APPLICATION NO.	FILING DATE	FIRST NAMED INVENTOR	ATTORNEY DOCKET NO.	CONFIRMATION NO.
10/510,375	02/22/2005	Jiri Babej	67562.15	8801

Office Action Summary

BABEJ ET AL.

combination with a metal plate (30) the fastener element comprising features as shown below in the following figure which is a copy of Oates' Fig. 5.

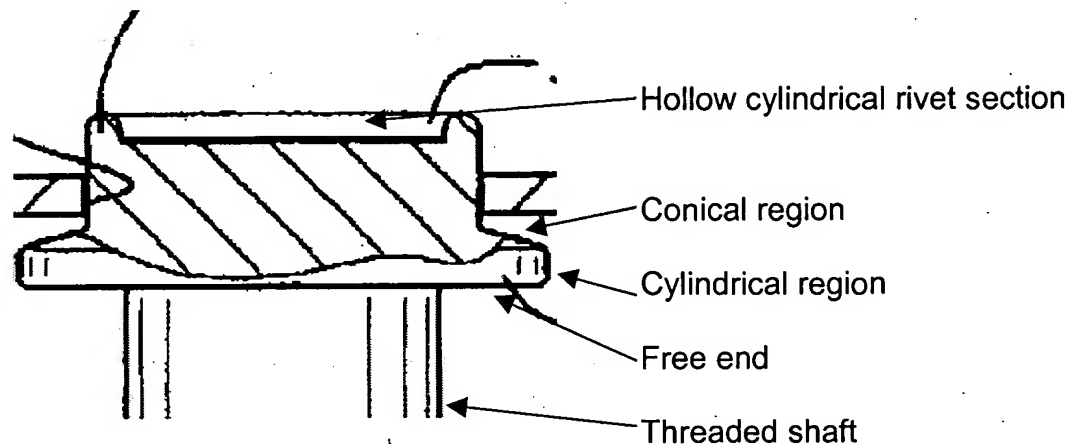
Claims 43-46, 53 and 54 are rejected under 35 U.S.C. 102(e) as being anticipated by Oates (US 6,799,929). Oates discloses a fastener element (40) in

As can be seen in the above figure the cylindrical region has a diameter no larger than the larger diameter end of the conical region and the hollow cylindrical section is formed adjacent the smaller diameter end of the conical region. In regards to claims 45-46, the noses are read as the corners of the polygonal shape (see Fig. 4) at the location where they meet the conical region.
